Z-62  
(2016)

MILFORD CHURCH ROAD TRACT  
 COBB COUNTY, GEORGIA - 19th DISTRICT, 2nd SECTION, LAND LOTS 549 & 562  
 VENTURE HOMES, INC.  
 COBB COUNTY, GEORGIA

TITLE	ZONING PLAN
DATE	5/20/16
PERMITS	160152pw-1
CONTRACT	160152pw-1
DRAWN BY	TS
CHECKED BY	TS
SCALE	1" = 30'
SHEET	Z-1
	1 OF 1

### **Z-62 VENTURE HOMES**

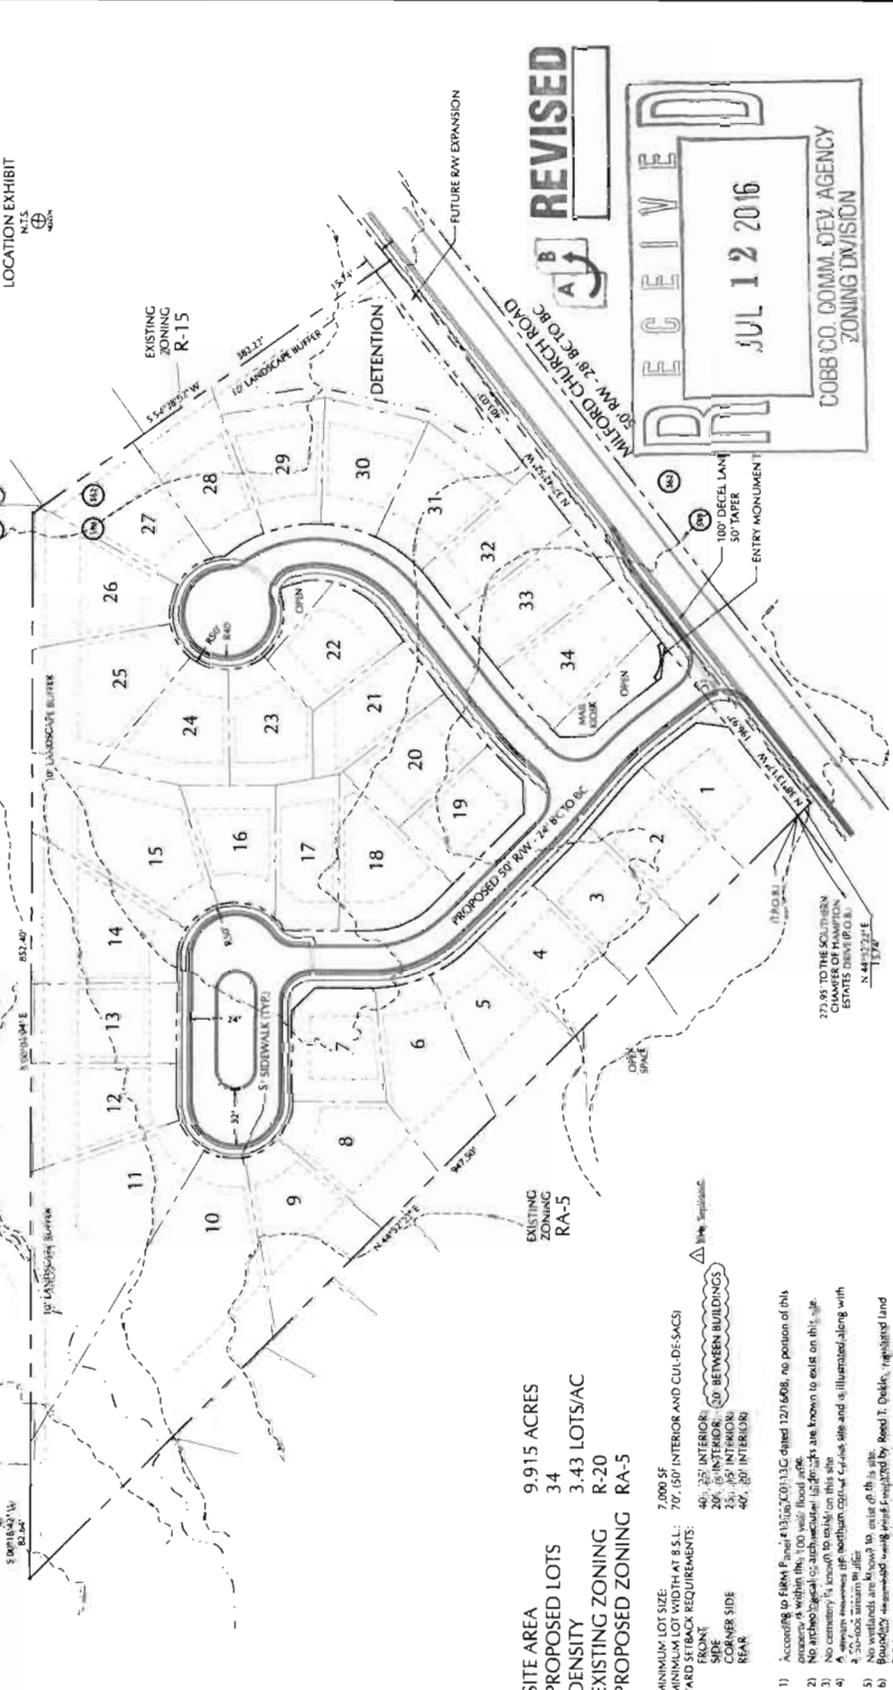
1. This parcel has an existing lake located onsite that has been recently drained. There may be wetlands associated the lake bed and stream buffers that may impact the site layout. Any required buffer variances or Corps of Engineers permitting of fill placement within wetlands or waters of the US must be obtained prior to permitting.

2. The majority of the site drains through the existing dam into and through the Rustic Village Subdivision to the south. A portion of the northeast corner of the site drains to the east through two estate-sized residential parcels before flowing into the Rustic Village Subdivision. Portions of Lots 10-14 will bypass proposed stormwater management facility, therefore all impervious runoff will be required to discharge to the street to limit offsite bypass.

3. There is an existing detention pond located just upstream of the site within the South Hampton Estates Subdivision. Adequate conveyance of this discharge must be provided through the site.

4. A downstream analysis at the Rustic Drive culvert will be required to verify no adverse impact or increase in headwater pool elevations. There are two existing residences whose lowest floors are located near or below the low point of Rustic Drive.

Milford Church Road is classified as a major collector and according to the available information the existing right-of-way does not meet the minimum requirements for this classification.

- A. It is Staff's opinion that the applicant's rezoning proposal will permit a use that is suitable in view of the use and development of adjacent and nearby properties. Located along Milford Church Road, a major collector roadway, the proposed subdivision is immediately adjacent to the south of the South Hampton Estates subdivision which is also zoned RA-5 and has a density of 3.37 units per acre (upa).

1. Revised site plan received by the Zoning Division on July 12, 2016, with the District Commissioner approving minor modifications;
2. Landscape plan to be reviewed and approved by the County Arborist;
3. Water and Sewer Division comments and recommendations;
4. Fire Department comments and recommendations;
5. Stormwater Management Division comments and recommendations;
6. Department of Transportation comments and recommendations; and
7. Owner/developer to enter into a Development Agreement pursuant to O.C.G.A. §36-71-13 for dedication of system improvements to mitigate traffic concerns.
